SECTION 4.55 APPLICATION
33 UPPER CLIFFORD AVENUE
LOT C DP 102834 FAIRLIGHT
DA166/2015

S4.55 APPLICATION DRAWING LIST

DEVELOPMENT CONSENT DA-166/2015
NORTHERN BEACHES COUNCIL
DEVELOPMENT MODIFICATION MOD2018/0715
BASIX CERTIFICATE No A336197_03

S4.55 APPLICATION
ADDITIONS & ALTERATIONS
33 UPPER CLIFFORD AVENUE
FAIRLIGHT

**BUILDING ELEVATION
SHEET 1**

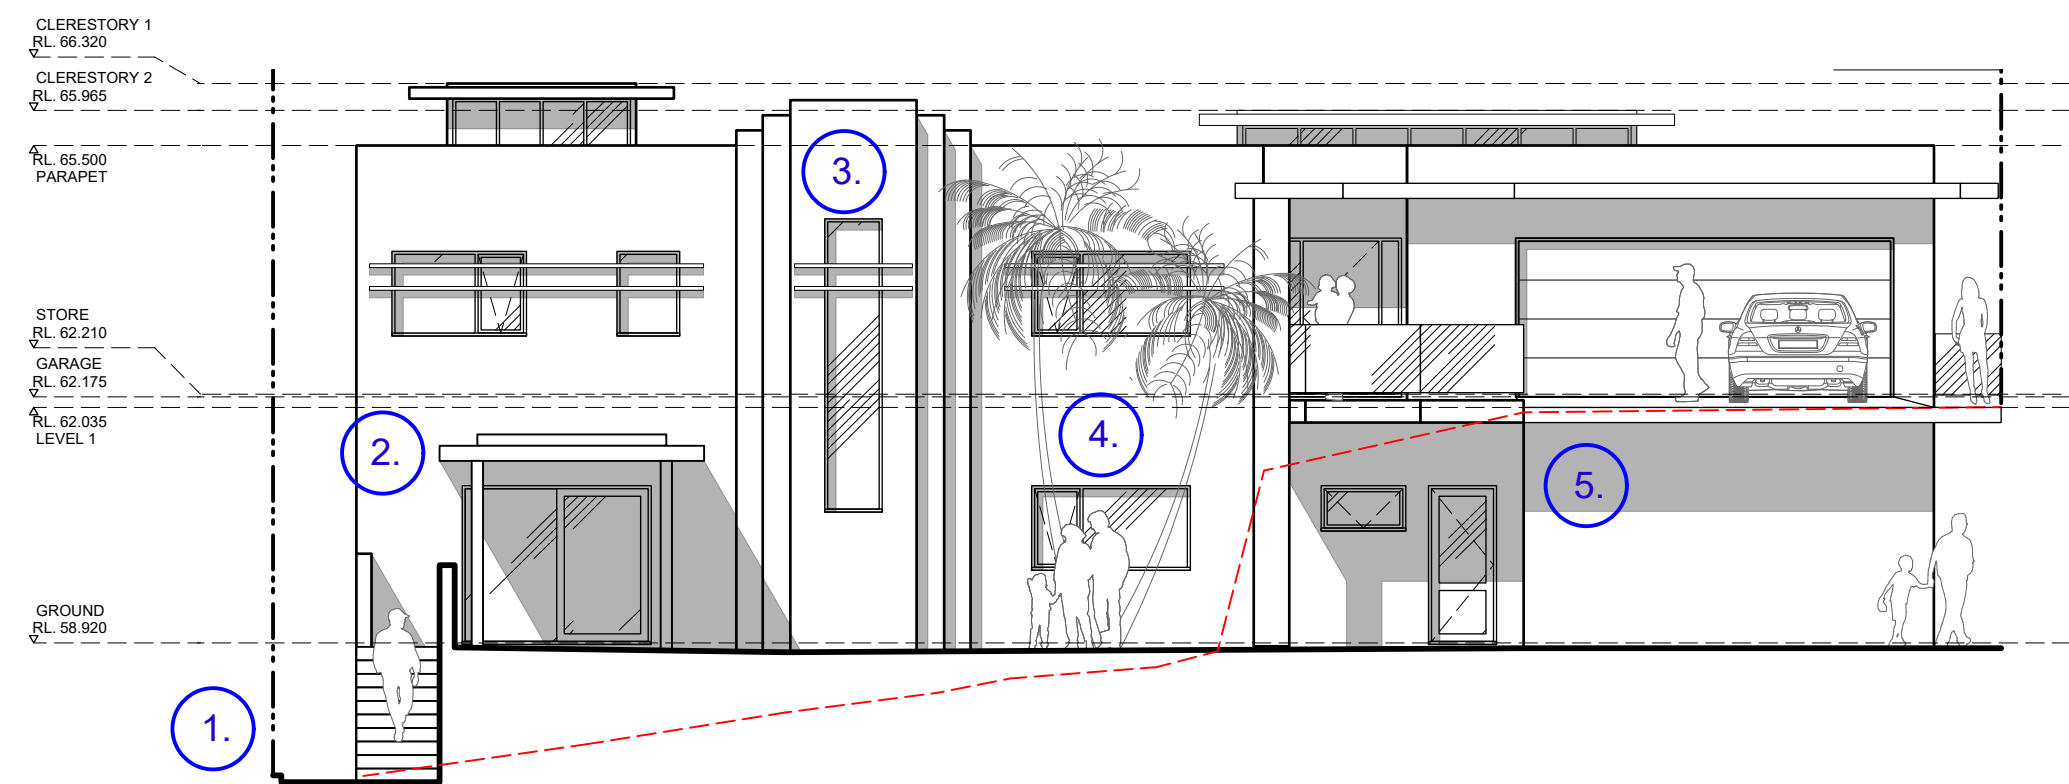
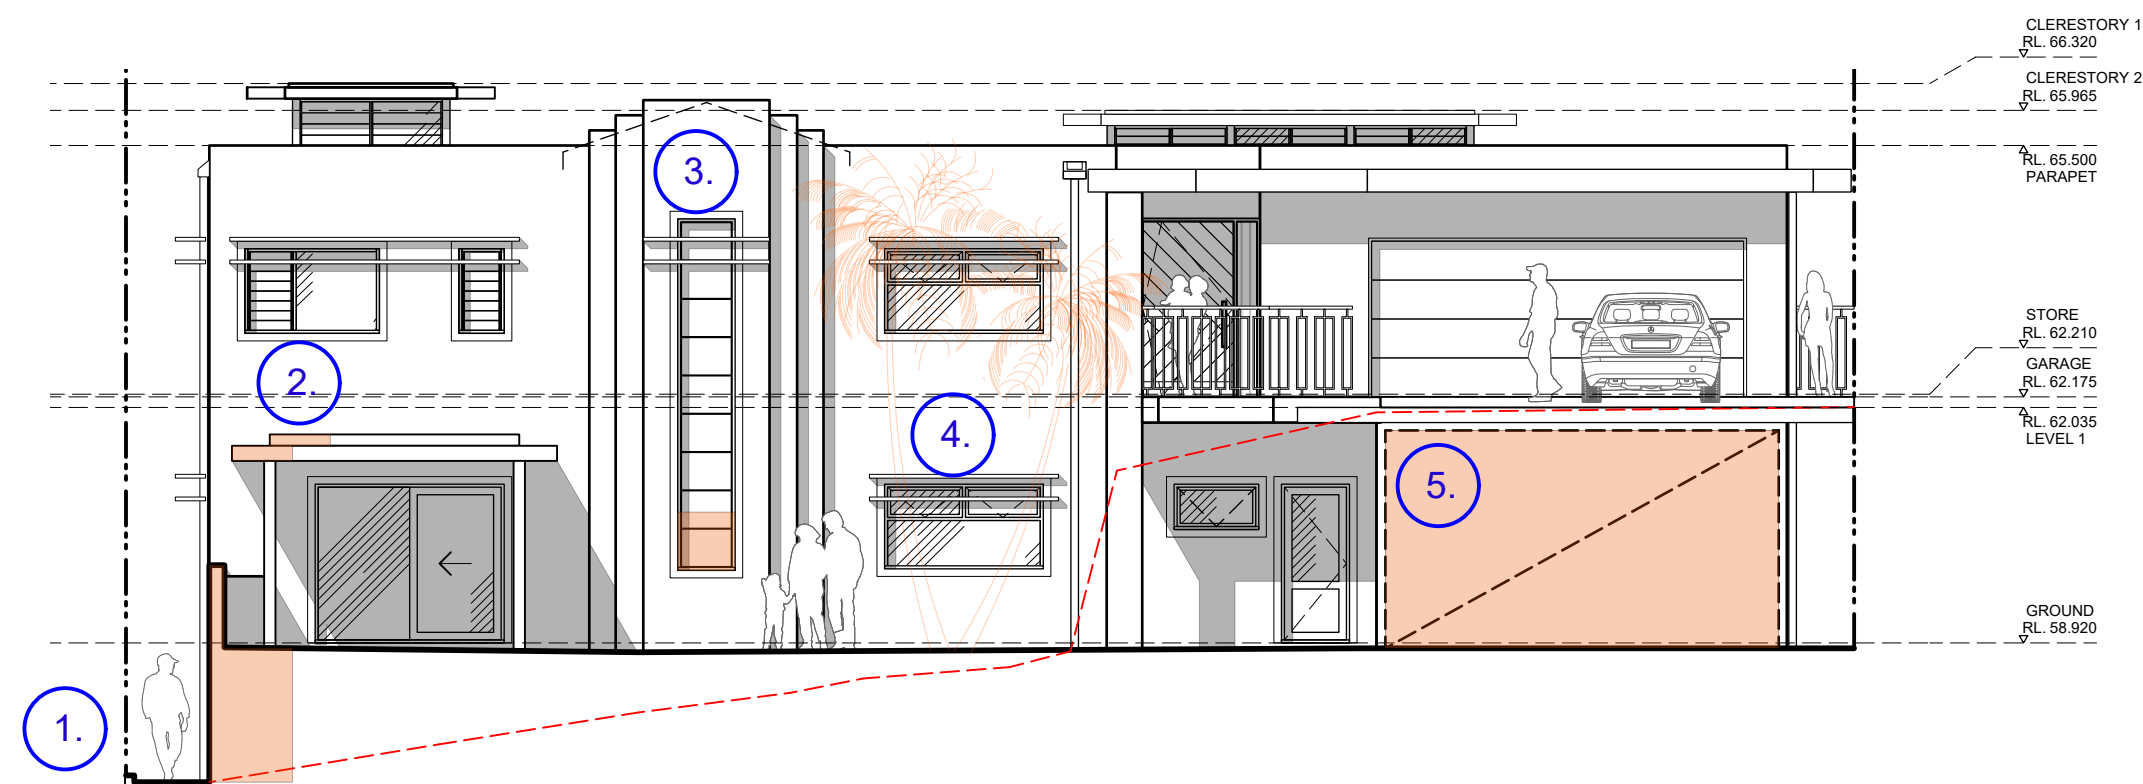
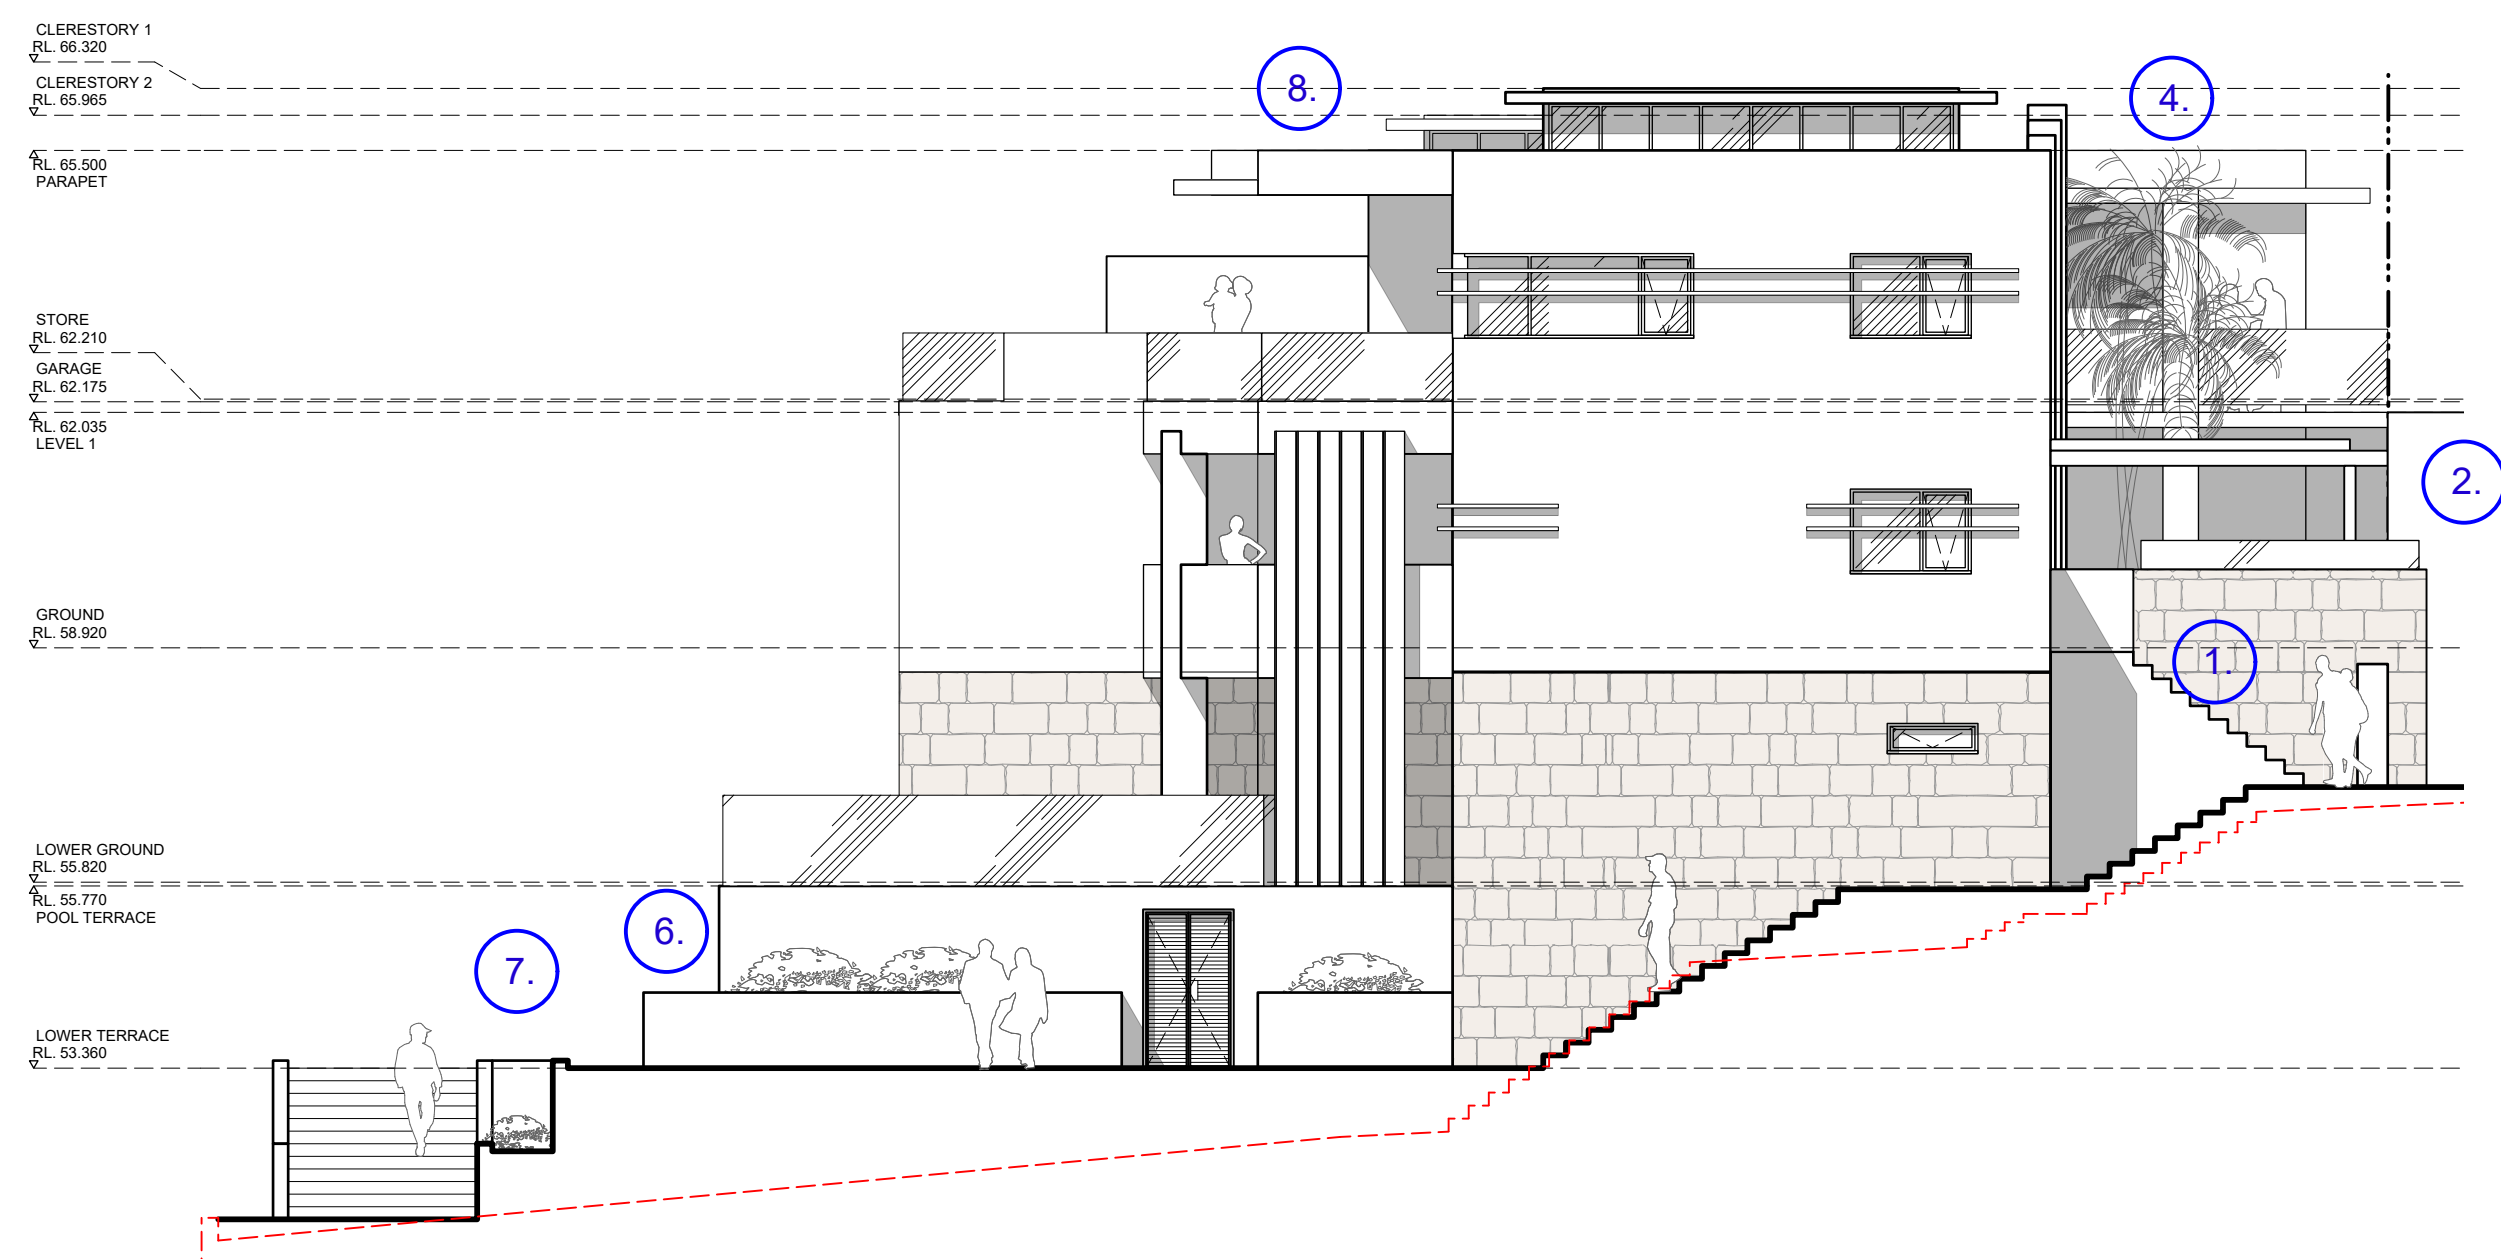
1. REMOVE COURTYARD STAIR ACCESS
2. MINOR INCREASE TO COURTYARD CANOPY
3. REVISED STAIR WELL WINDOW
4. REMOVE EXISTING COURTYARD PALM TREES
5. RELOCATE RAIN WATER TANK
6. ADDITION OF LEVEL CHANGE TO TERRACE PATHWAY
7. MINOR CHANGE TO RETAINING WALL
8. UPDATE ROOF DESIGN TO COMPLY WITH PREVIOUS S4.55 CONDITIONS - REMOVE PART OF PARAPET
